Service Campaign Bulletin

Campaign No. 2012070002, November 2012

SUBJECT: **Models 164, 171, 203, 204, 207, 209, 211, 212, 216, 219, 221, 230, 251, 463**
Engines 272 and 273
Model Years 2005 - 2011
Retrofit Adapter Wiring Harness on Camshaft Adjustment Solenoids

Figure 1

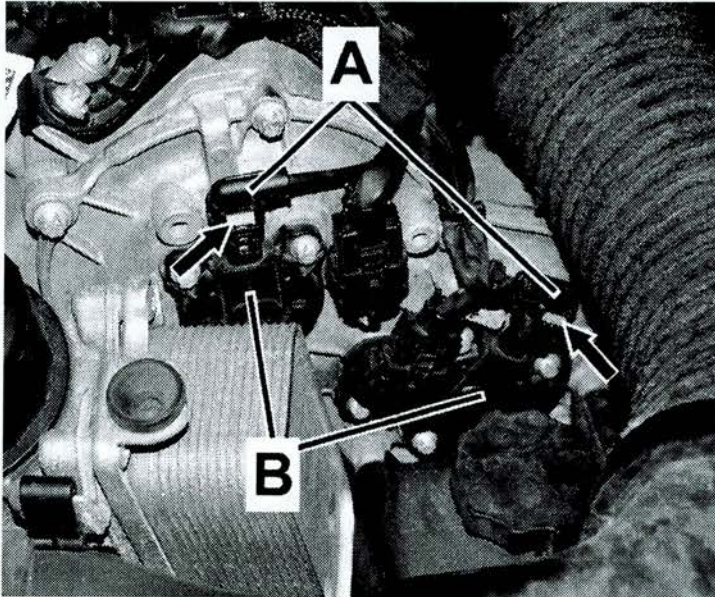
1. Remove top engine cover to get access to camshaft adjustment solenoids as required.
2. Disconnect camshaft adjustment solenoids from engine harness connectors (A, Figures 1 and 2):
 - Carefully unlock engine harness connectors (A) by squeezing and **partially** pulling out locking tabs (arrows) using pocket screw driver.
 - Disconnect camshaft adjustment solenoid connectors (A) from camshaft solenoids (B).

Figure 2

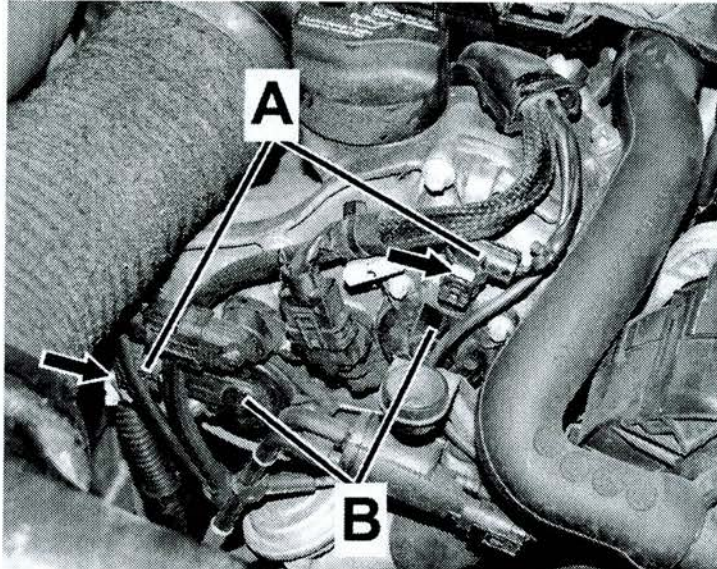
Note: Shown on engine 272

Figure 3

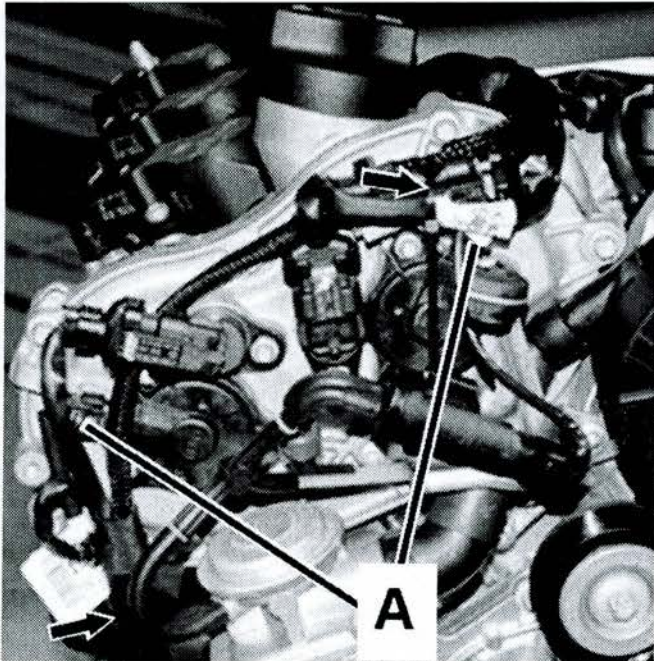
3. Connect adapter harnesses (A, Figures 3 and 4):
 - Connect adapter harnesses (A) between connector on camshaft adjustment solenoid and engine harness.
 - Push locking tabs (arrows, Figures 1 and 2) into connectors to secure (total of 8 locking tabs).
4. Secure adapter harnesses with cable ties.

Ensure harness adapters are properly secured using cable ties (arrows, Figures 3 and 4) to prevent wire chafing and/or damage from hot engine parts, (e.g. oil cooler [B]).
